Dispersion of aqueous effluent from Hunterston power stations Annex – Additional Scenarios

Reference: ENE – 0328A/R2

To: [REDACTED]
EDF Energy Nuclear Generation Ltd
Hunterston B Power Station

Figure 1 – Activity concentration of H-3 in unfiltered seawater in the swimmer dilution volume for alternative discharge arrangements to the bank (Scenario 7)

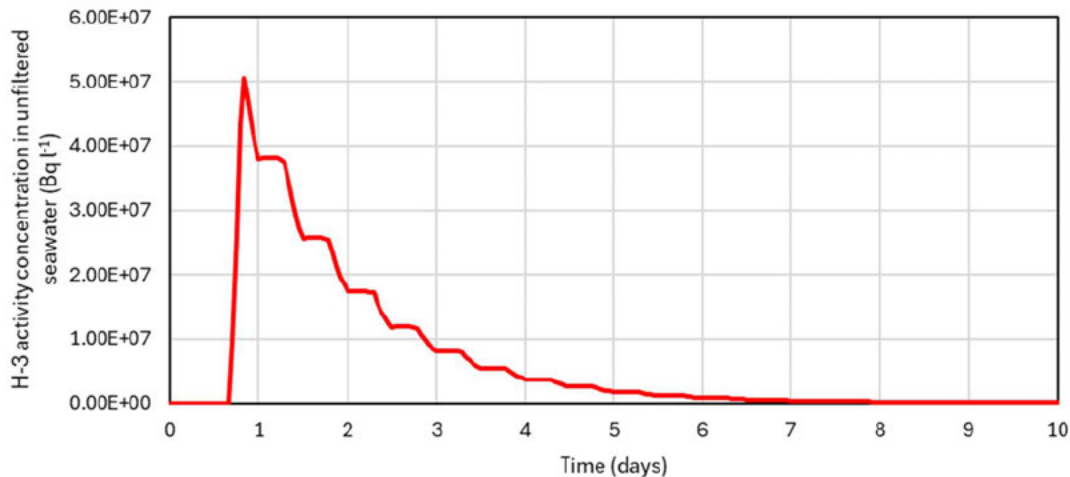
An additional scenario was requested for Hunterston A and Hunterston B permit limit discharges to the bank compartment, centred around low tide. The results for this scenario were used to inform a dose assessment for an open water swimmer.

An additional scenario was requested for Hunterston A and Hunterston B permit limit discharges to the bank compartment, centred around low tide. The results for this scenario were used to inform a dose assessment for an open water swimmer.

Figure 1 shows the variation of the activity concentration of H-3 in unfiltered seawater in the dilution volume occupied by the swimmer compartment over the first 10 days. The peak value is reached shortly after the discharge.

The scenario reflects the unlikely scenario where the annual aqueous discharge limits for Hunterston A and Hunterston B are released simultaneously during one discharge. Maximum activity concentrations calculated in GoldSim Scenario 7 were scaled to a swimmer dilution volume of 12,500 m³, based on SEPA definitions (the volume occupied by the swimmer would cover an area of 50 m by 50 m and be about 5 m deep).
